**Economic and Social Council**Distr.: General
17 April 2018

Economic Commission for Europe**Inland Transport Committee****Working Party on Inland Water Transport****Working Party on the Standardization of Technical
and Safety Requirements in Inland Navigation****Fifty-third session**

Standardization of technical and safety requirements in inland navigation:**Recommendations on Harmonized Europe-Wide Technical Requirements for Inland Navigation
Vessels (Resolution No. 61, revised)****Aligning of the Annex to Resolution No. 61, revised, with the
European Standard laying down Technical Requirements for
Inland Navigation Vessels (ES-TRIN) Edition 2017****Note by the secretariat****Mandate**

“Figure 1: Inland ECDIS equipment, standalone equipment connected to the radar equipment (system configuration 2)

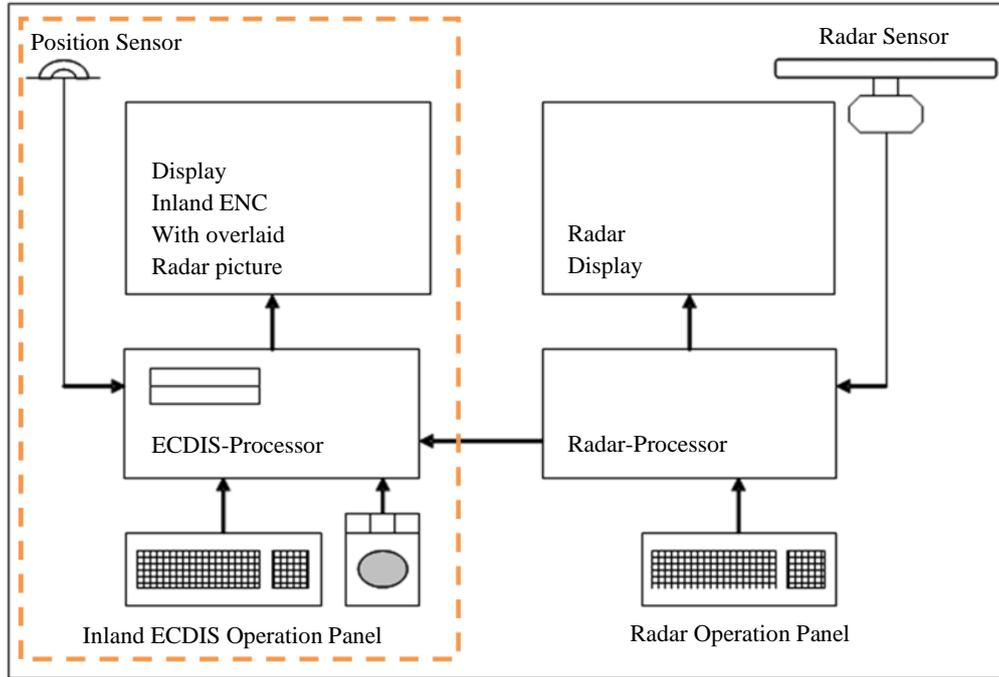
A new appendix with two figures has been added to Section I of Annex 5. It could be added as well to the relevant Appendix in Resolution No. 61:
